## **HOLLAND® Coupling Products**

### **Product Change Notification - Air Chamber for Air Cushioned Snubber**

## **Effective February, 2021**

Tel 800.876.3929 info@safholland.us 2021-02-01 XL-PH20086WI-en-US Rev A

#### **Air Chamber Dimensions**

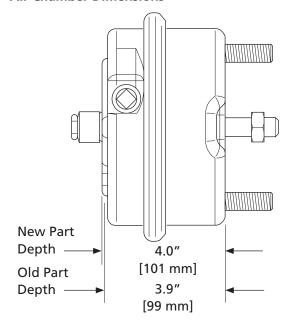
A change was made to the air chamber for the air cushion snubber used for pintle hooks in doubles and triples trailer applications. This change caused the overall depth across the chamber body halves to increase 2 mm (.08").

Fit, form and function remains the same with exception to the chamber body depth described above.

Mixing old and new air chambers will not jeopardize functional integrity.

There is no physical identifiable change to the air chamber other than the change described above.
